CHANGE ORDER

Project Name: **Haverhill Consentino Middle School** CO No.

Architect's Project No. **21-0818**

See attached list of 8 item(s) for a total of**\$55,398.36**

Sheet Title
PR33R1 - LEVEL 1 AREA A&B CORRIDOR
DISPLACEMENT UPDATE

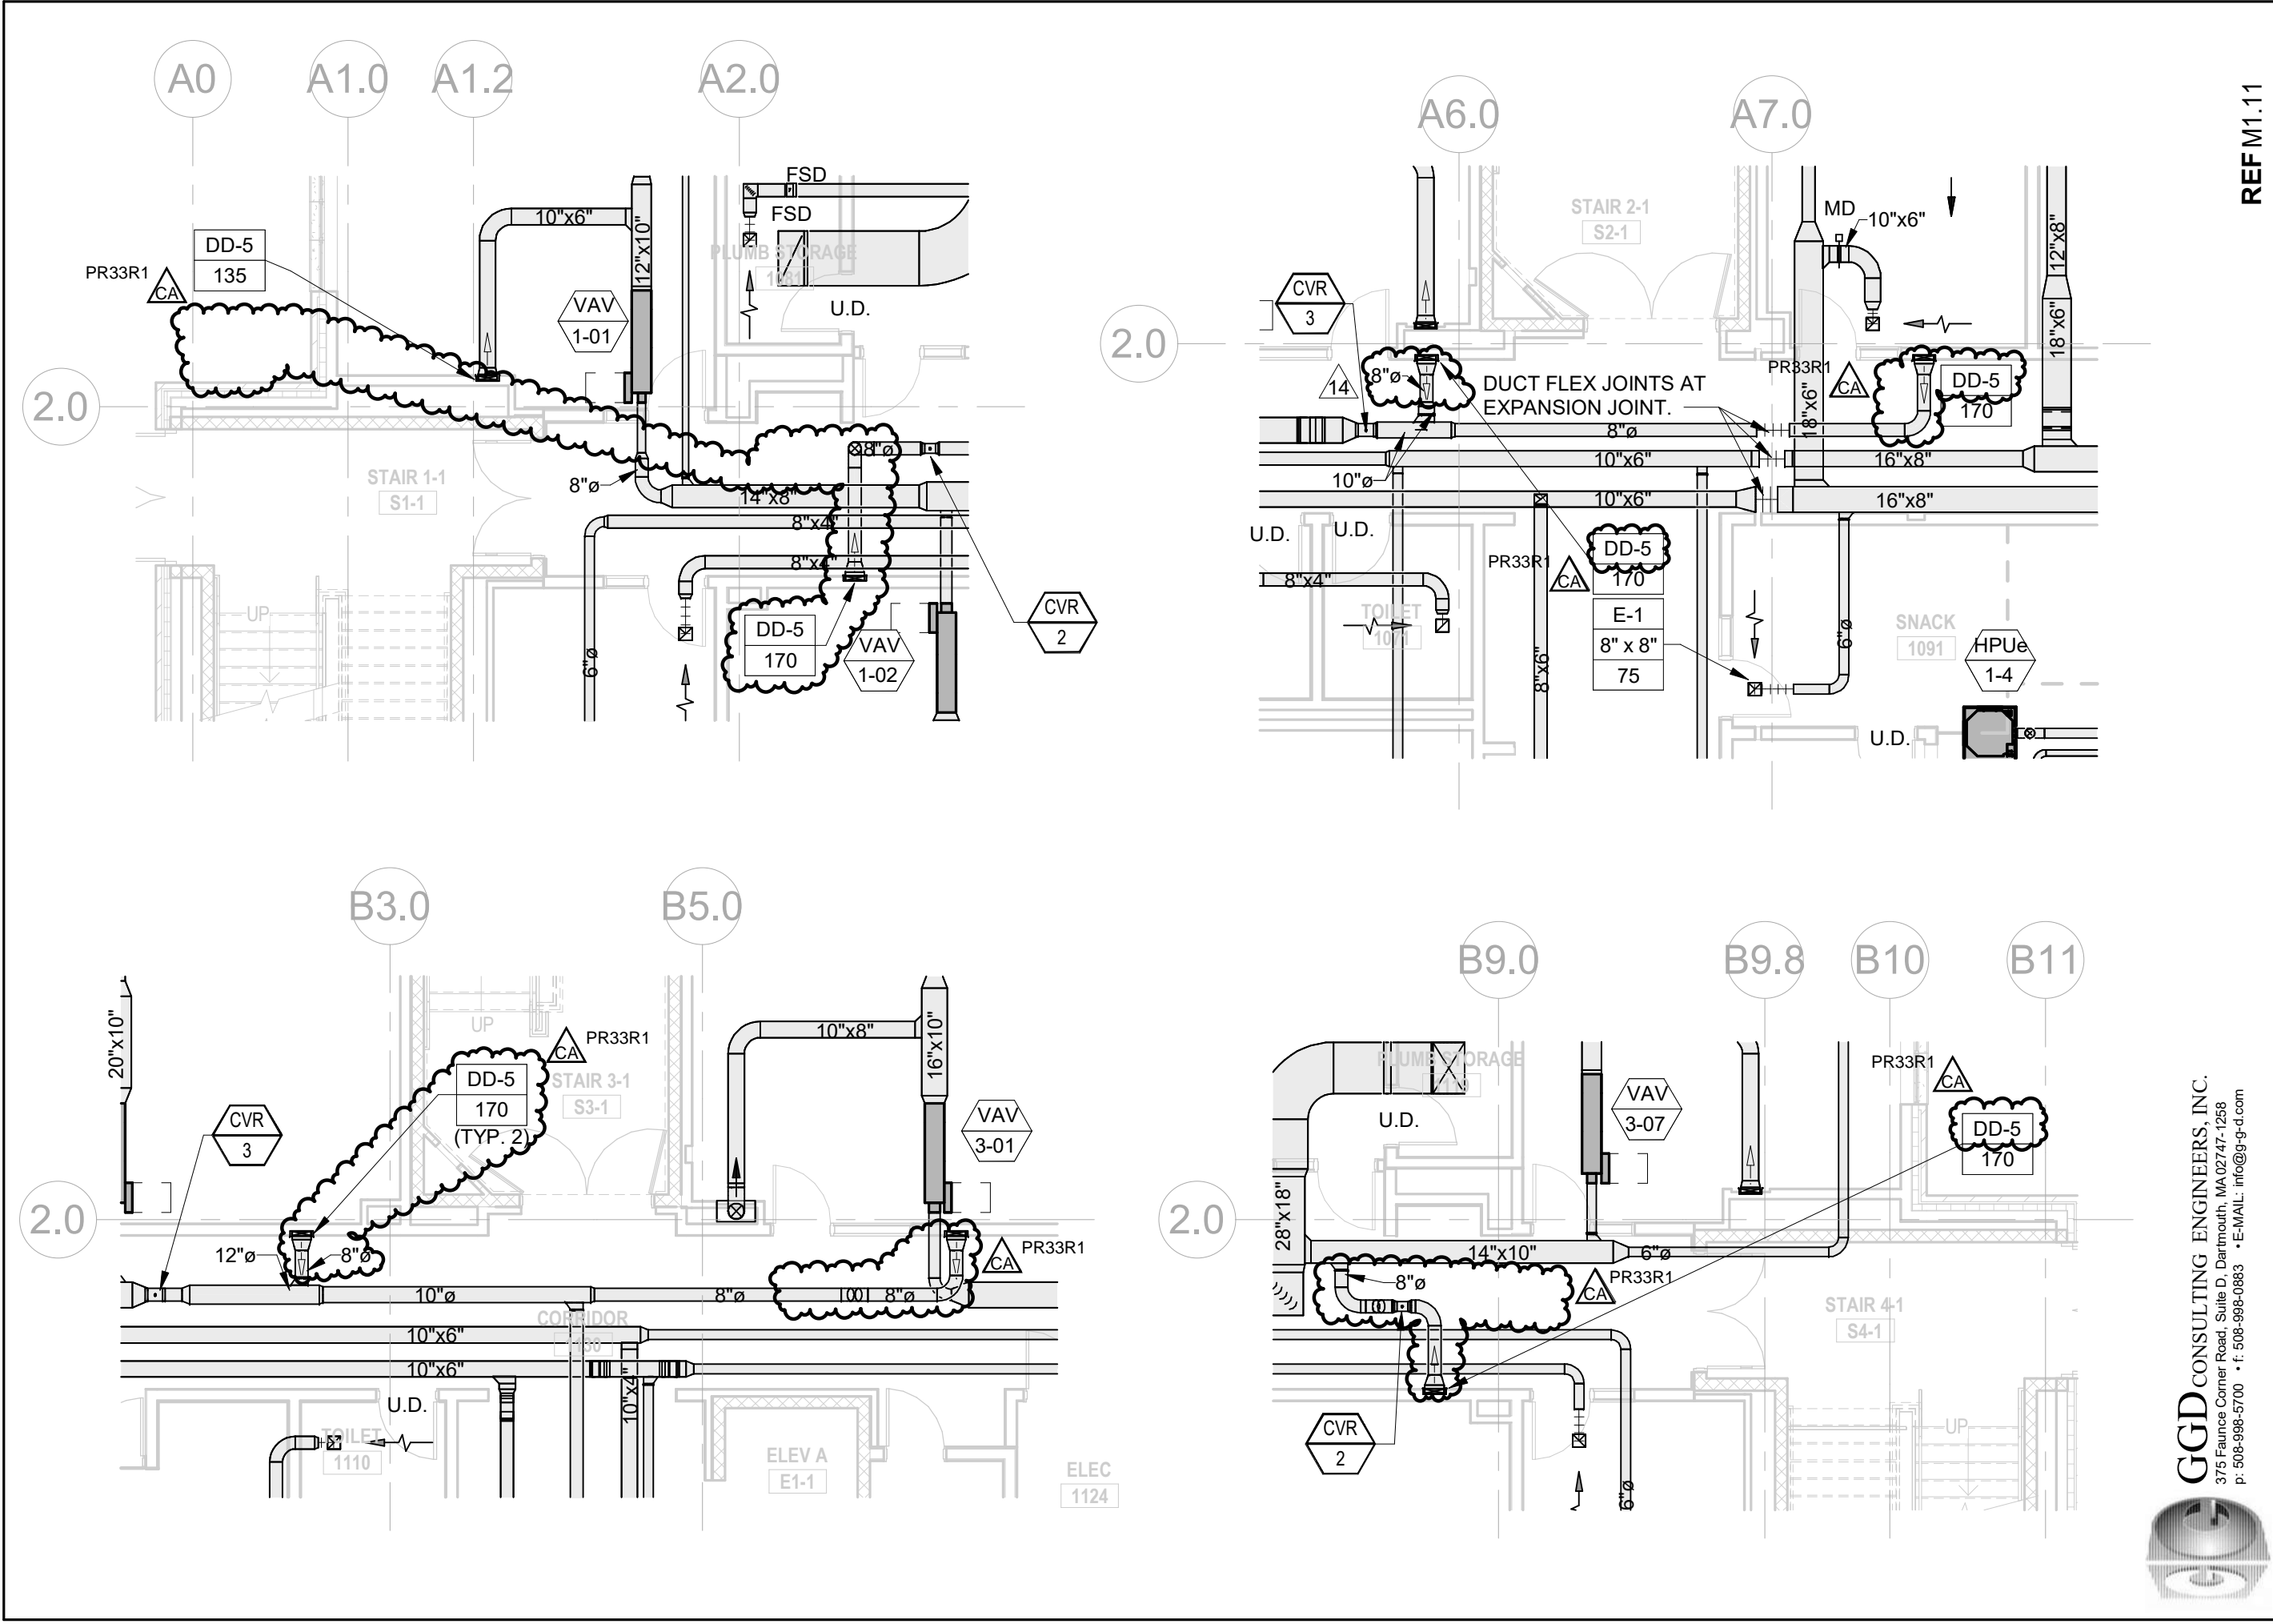
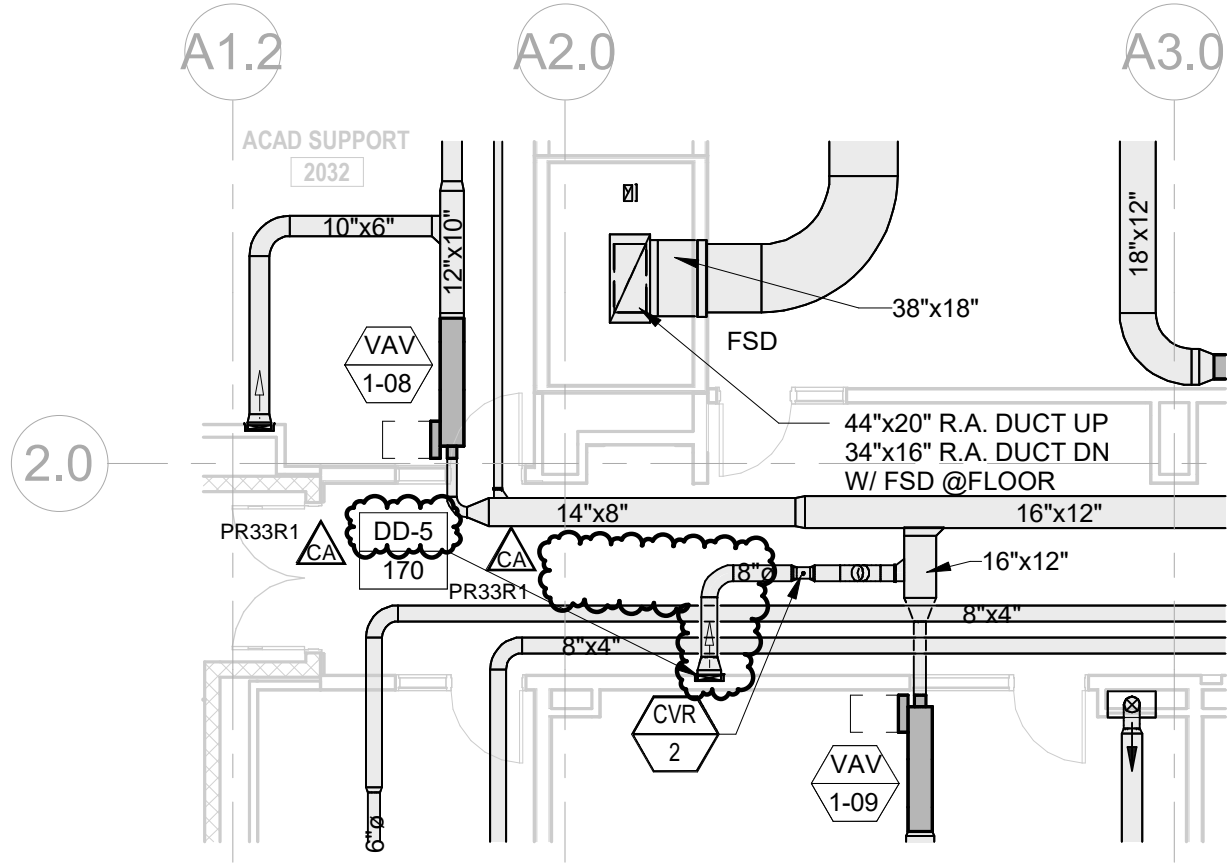
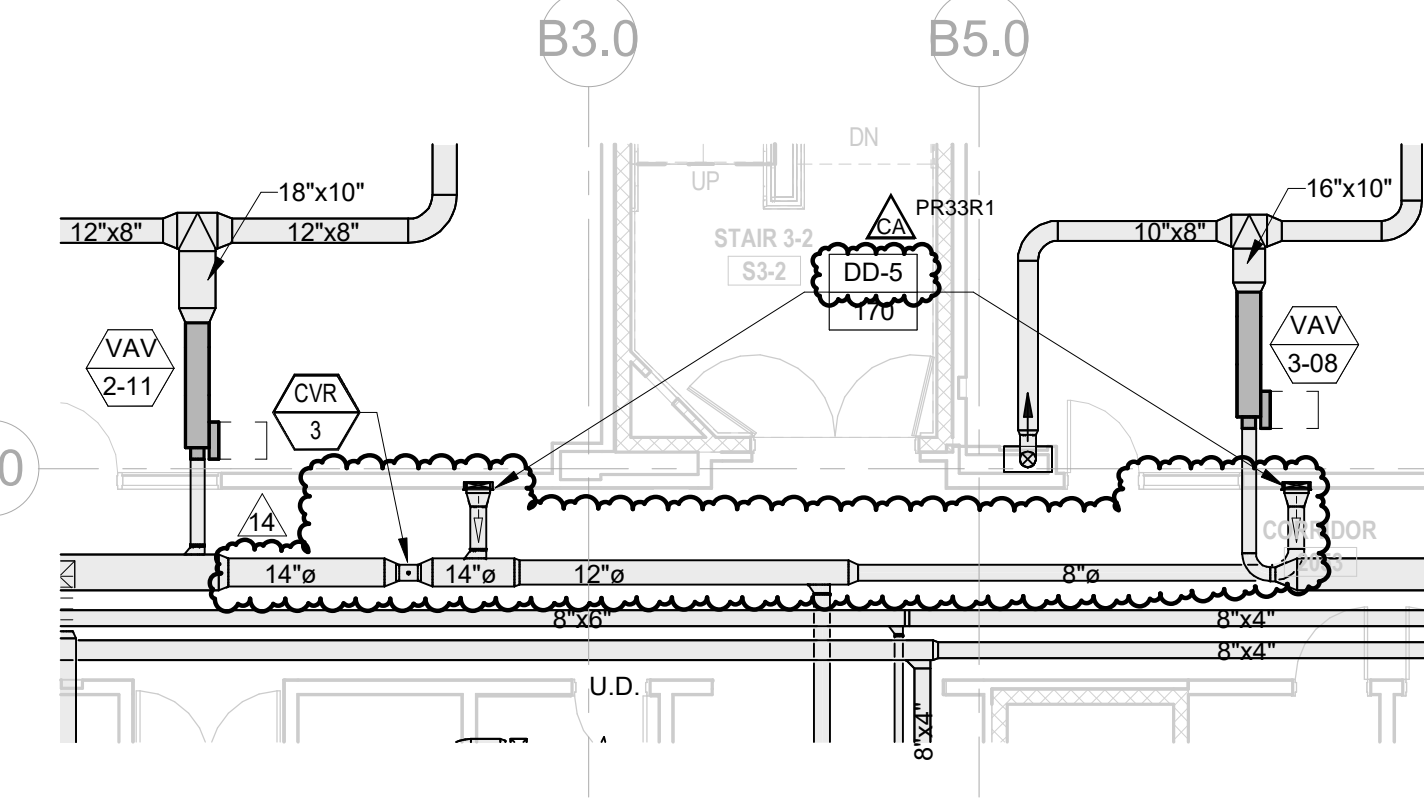
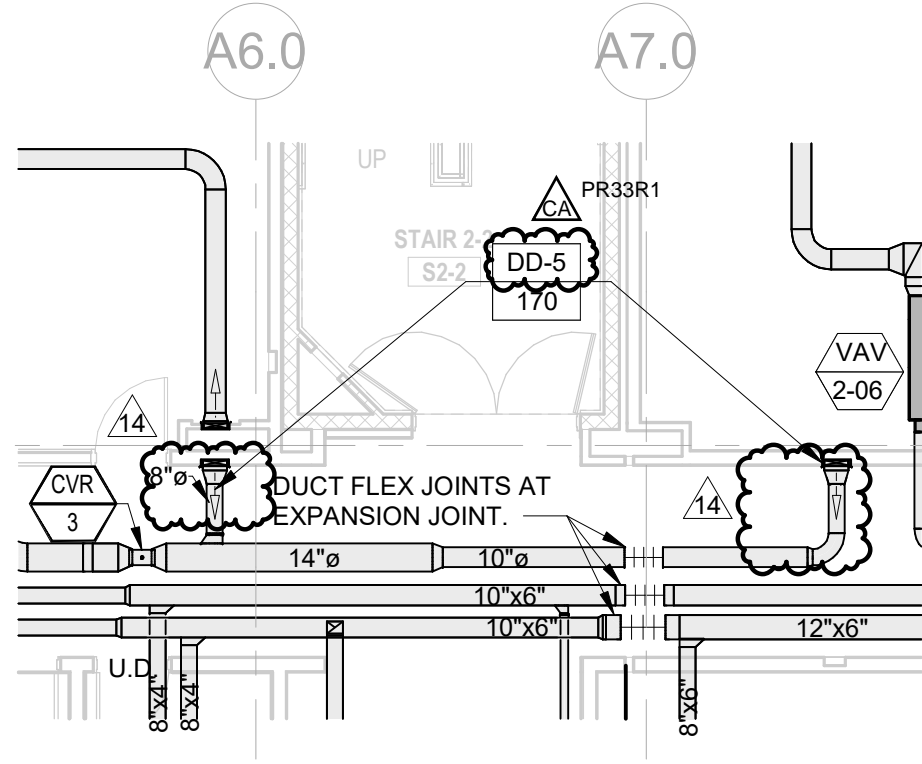
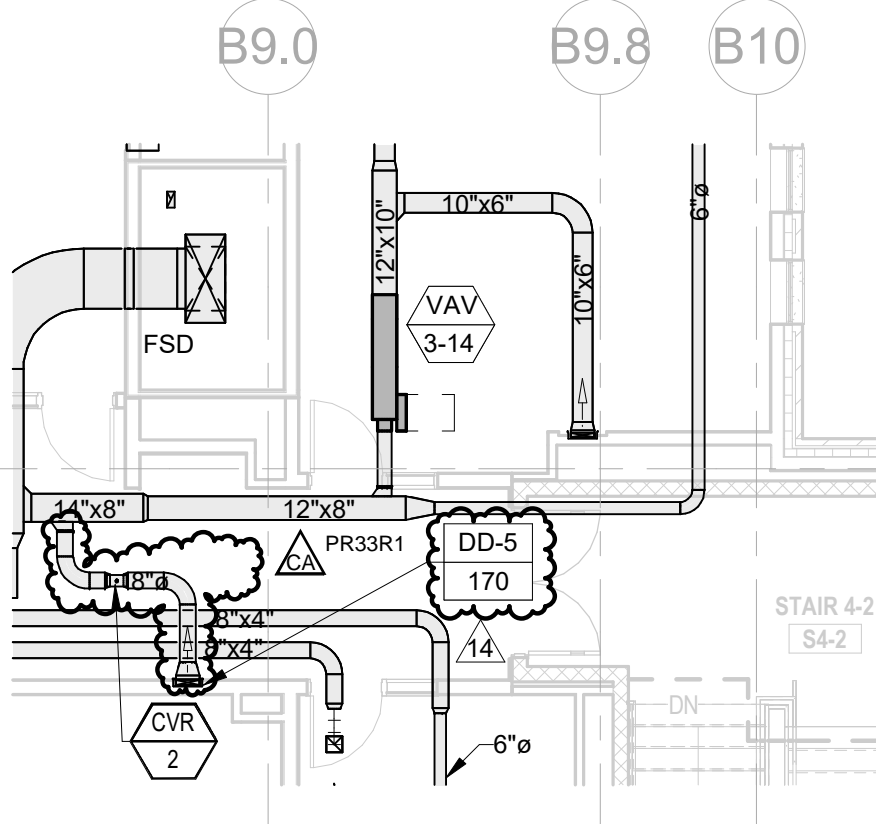
Refer to attached Equipment plans AQ1.11 and AQ1.31 for proposed wall mounted displacement cabinets in Area A/B Corridors. Make similar revisions to AQ1.21 and AQ1.41.

Per coordination call with Contractor and design team, Corridor ceiling displacement to be revised to wall mounted units. See attached sketches JD-76-JD-79 for proposed design changes to mechanical sheets M1.11, M1.21, M1.31, M1.41.
